Product Highlights

Change Notice

PCN No: 144

PCN No: 125

PCN_125_AL295

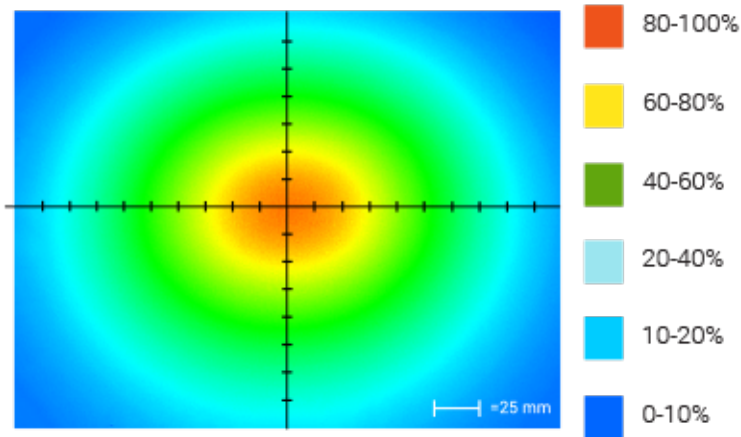
In an effort to improve our products, Advanced illumination (Ai) will update the LEDs used in the AL295 design. This change will result in a brighter, more uniform light at the same price*. Customers may still buy the current revision of this model until September 2th of 2016. After that time, orders for these products will be converted to their respective AL295 Revision A models.

This LED change will result in additional wavelengths being available: 365nm, 375nm, 385nm, 395nm, 405nm, 470nm, 505nm, 590nm, 660nm, 730nm, and 940nm. Additionally the white LED color temperture will be changing from 6100K to 5500K.

Orders for customized (dash numbers) versions of AL295 will be honored until January 13th of 2017. Ai will be actively working with customers for those products to simplify the transition.
